Office Action Summary

10/728,753

MURATA, SHIGERU

DETAILED ACTION

Fig. 2A

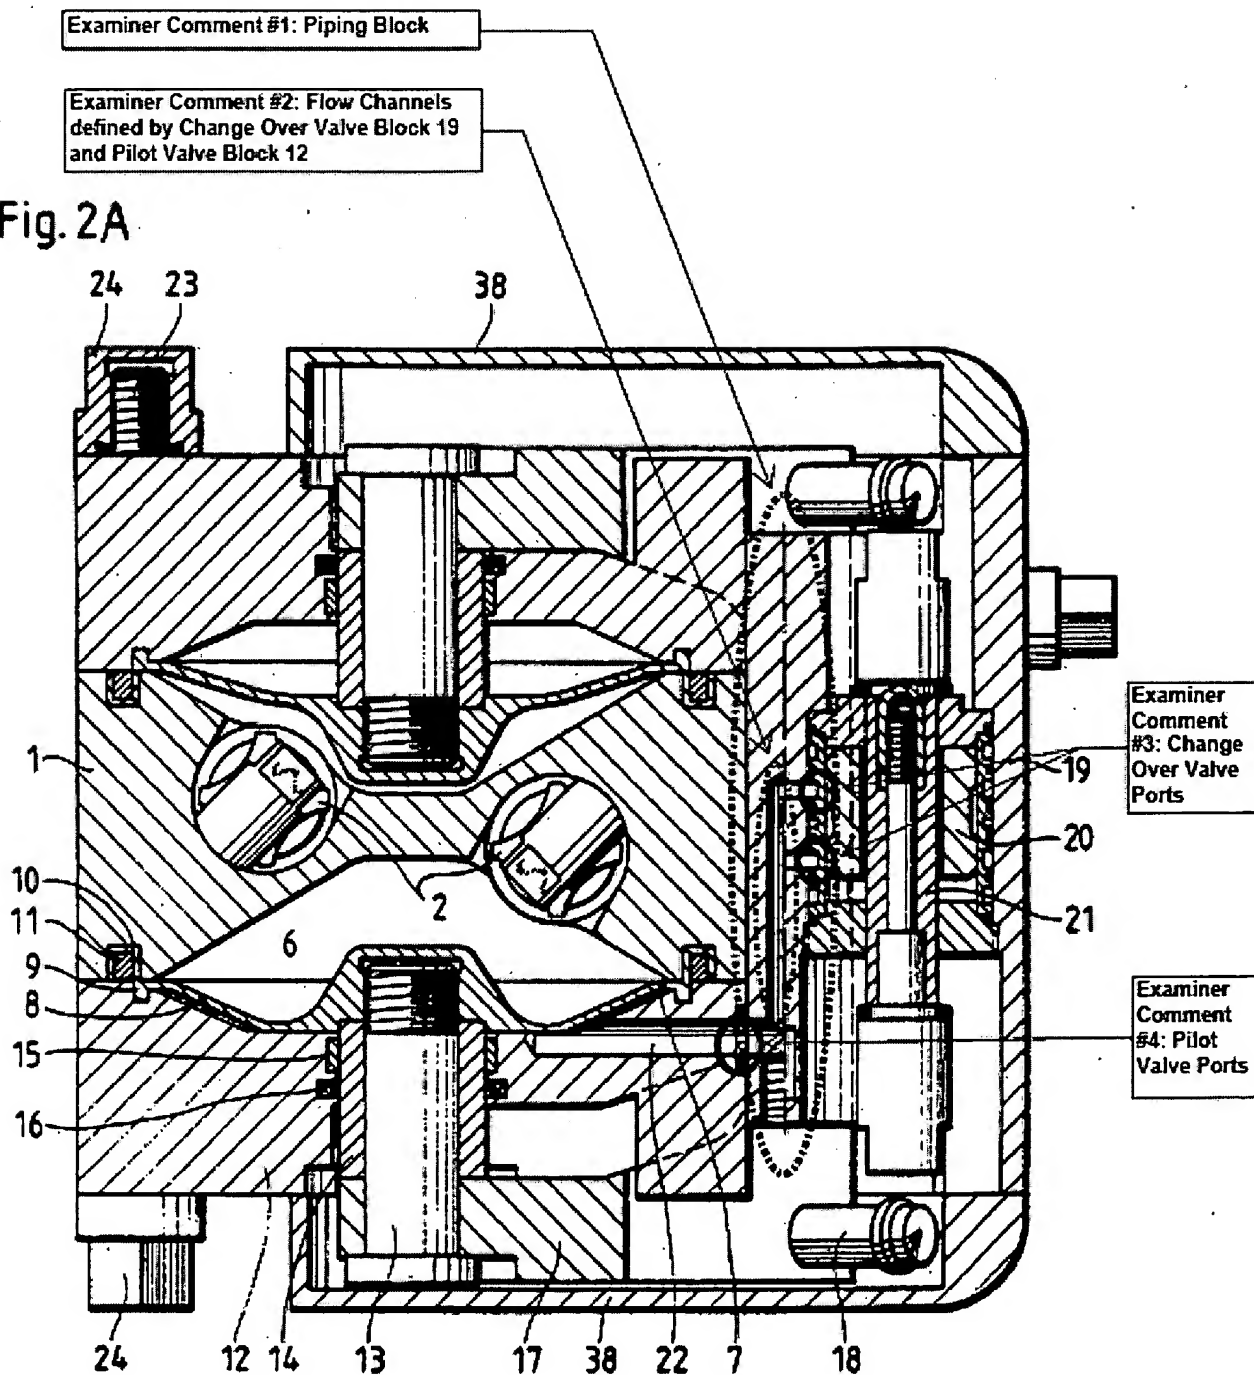
Claims 1-4 rejected under 35 U.S.C. 102(b) as being anticipated by Budde 5,261,798. Budde teaches all the limitations of the invention as substantially claimed for a reciprocating fluid transfer pump including: a fluid once having suctioned into a fluid delivering chamber 6 is discharged by expanding and contracting a barrier membrane 7 attached to an end portion of a

center rod 13 capable of making a reciprocating movement relative to a main body block 1 and defining said fluid delivering chamber 6 and a driving chamber 8, a peripheral portion of said barrier membrane 7 is clamped and thus secured fixedly to said main body block 1 via a main ring 9 and a sub ring 10, and a pilot valve assembly block 12 having a pilot valve 22, operated via 17, integrated therein as one body for detecting a reciprocating motion of said center rod 13 is pressed against and thus secured fixedly to said main body block 1 with the aid of said main ring 9 and said sub ring 10; a change-over valve assembly block 19 having a change-over valve 20 integrated therein as one body for switching movable directions of said center rod 13 (col. 4 ll. 22-30) is secured fixedly to said main body block 1, wherein said change-over valve assembly block 19 and said pilot valve assembly block 12 are interconnected via a piping block (comment #1 on Fig. 2A) defining flow channels (comment #2 on Fig. 2A) for connecting change-over valve ports (comment #3 on Fig. 2A) with pilot valve ports (comment #4 on Fig. 2A); change-over valve ports (comment #3 on Fig. 2A) and pilot valve ports (comment #4 on Fig. 2A) connected to flow channels (comment #2 on Fig. 2A) of a piping block via connectors, via 17 and 18; and a piping block (comment #1 on Fig. 2A) secured fixedly to the main body block 1 via the pilot valve assembly block 12, via 12 and 38. Reference is made to Figure 2A of Budde, included subsequent to paragraph 6.
